## SUBMISSION

### SUMMARY

My submission is that I **object** to the bulk and scale of the northern portion of the podium due to:

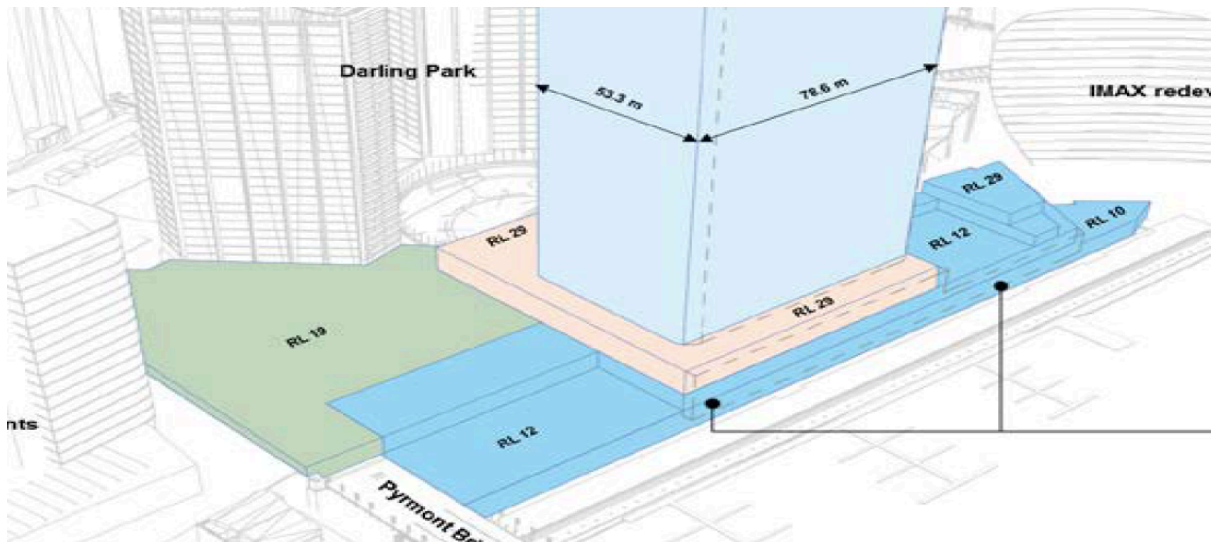
The issue of bulk and scale was by and far the dominant issue raised in submissions.

The Applicant (Planner and the Architect) response to submissions has made little attempt to address the issue and where he has he has increased the footprint in other parts of the project to ensure they maintain the 87,000sqm GFA – ‘minor’ was a good description for the effort to address such a significant issue.

#### *Cockle Bay Wharf Development approved RLs*

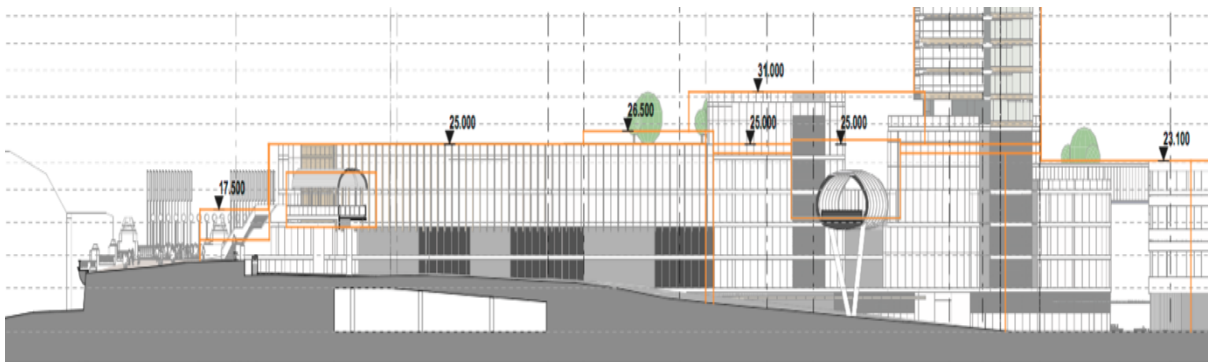
The Department as well as its independent expert design advisor have gave considerable attention to the issue of the Cockle Bay Wharf development on the visual impact on Pyrmont Bridge and Darling Harbour more broadly. It endorsed an RL for the north portion of the podium of 12 fronting onto the harbour and a RL of 19 over the roadway rising to RL29 for the podium of the tower.

The Department should give consideration to **amending the envelope for the northern portion of the podium consistent with the Cockle Bay Wharf approval (SSD 7684) to RL 12** for that portion of the podium facing the harbor and abutting Pyrmont Bridge and then rising to RL 19. These RLS should be maintained for 75 m to the south and then rising to RL 26.
